## SERVICE BULLETIN No. 6647-32-6

### LANDING GEAR - EXTENSION AND RETRACTION - CONTROL AND INTERFACE

#### MODIFICATION No. 4

#### INTRODUCTION OF MICROPROCESSOR PCB PT. NO. 001LG010450

Microprocessor PCB - Modification No. 4  
Figure 1

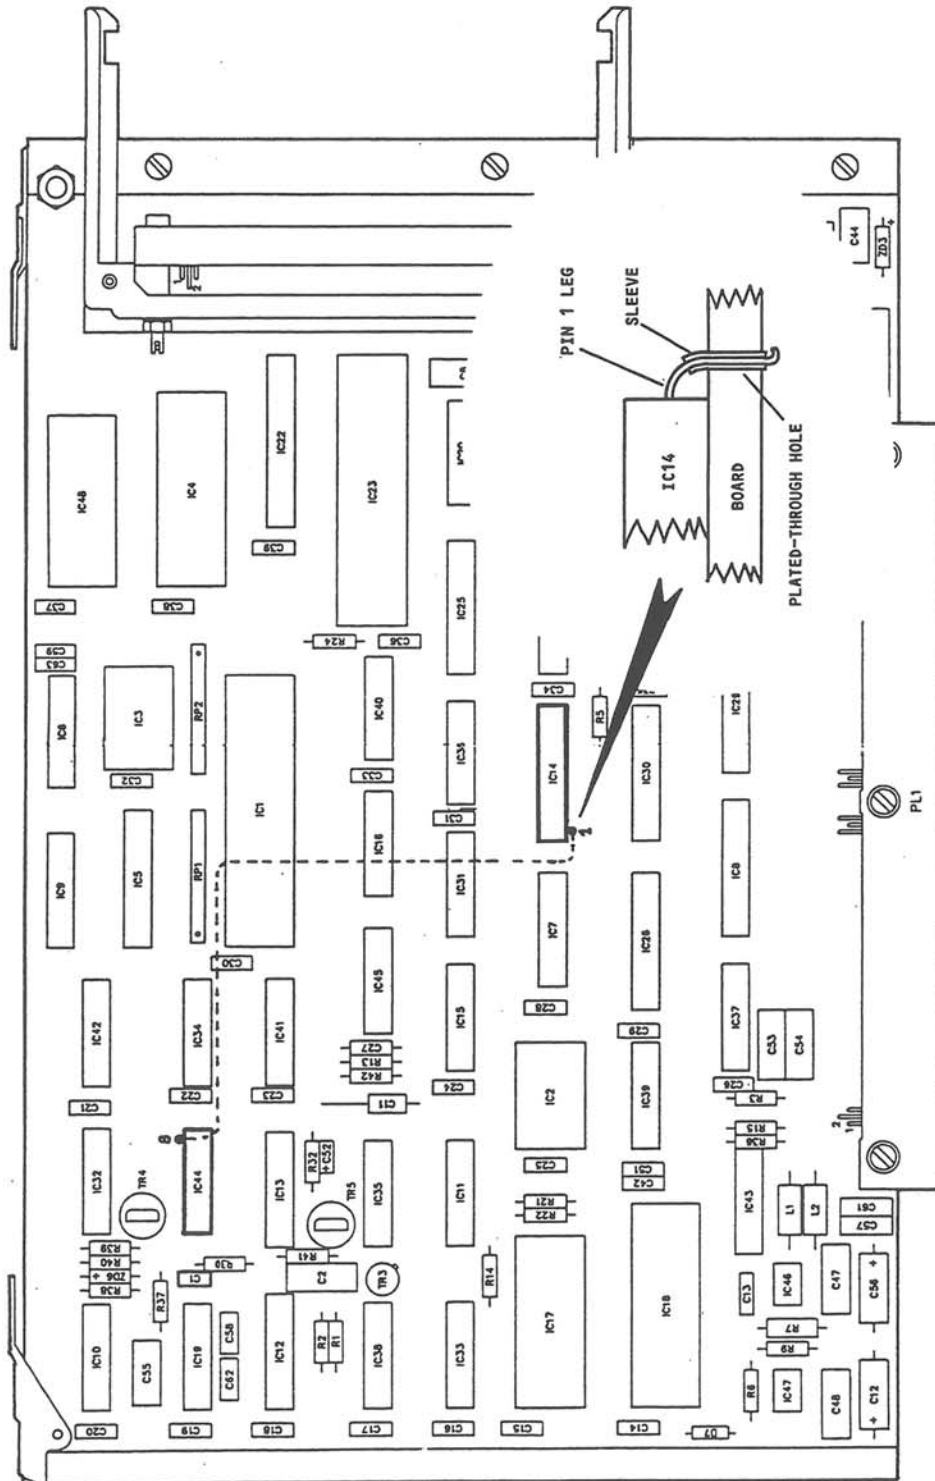
Capacitor C1 controls the timing of the first ARINC transmission after power-up. Changes of tolerance spread of C1 may cause problems during subsequent test. Modification No. 4 replaces C1 with a capacitor of lower value which will prevent test problems.

The integrated circuit latch IC14 controls the SELECT OUT pulse which is enabled during lane change. Again, tolerance spread in IC14 may cause problems during subsequent test. These problems occur because IC14 does not have a defined reset state. Modification No. 4 replaces IC14 with a different component which can be reset by a signal from the microprocessor. Test problems will not occur with the new IC14.

- (1) Refer to Fig. 1 and find IC14 and C1 on the PCB.
- (2) Apply small drops of toluene from a small brush on to the area of the conformal coating near IC14 and C1.
- (3) Stop for one to two minutes.
- (4) Clean the area with a strong, natural-bristle brush.
- (5) If necessary, apply more toluene and clean the area again.
- (6) Dry the area and then apply iso-propyl alcohol to the area to remove the toluene.
- (7) Do the procedures in sub-paras. (2) to (6) on the other side of the PCB.
- (8) Unsolder and remove IC14 and C1. Use a desolder tool to remove all solder from the plated-through holes.
- (9) Discard IC14 and C1.
- (10) Unsolder, remove and discard the wire link between pin 1 of IC14 and pin 8 of IC7.

- (1) Take the components from the Modification Kit, Pt. No. 001-LG-01-K010.
- (2) Install the new C1 on the PCB and solder in position.
- (3) Install the new IC14 on the PCB but do not solder its legs.
- (4) Refer to Fig. 1. Install the PTFE sleeve (in the Mod. Kit) over IC14 pin 1 leg and push the sleeve through the plated-through hole until it touches the IC body.
- (5) Cut the sleeve to the correct length and make a hook in the end of pin 1 leg. Make sure that there is no contact between pin 1 leg and the PCB track.
- (6) Solder all the IC legs except pin 1 to their track pads.

- (9) Refer to Fig. 1. Put the wire in position on the non-component side of the PCB, between IC14 and IC44.
- (10) Cut the wire to the correct length and remove a small part of the insulation. Solder the wire to pin 8 of IC44, on the non-component side of the PCB.
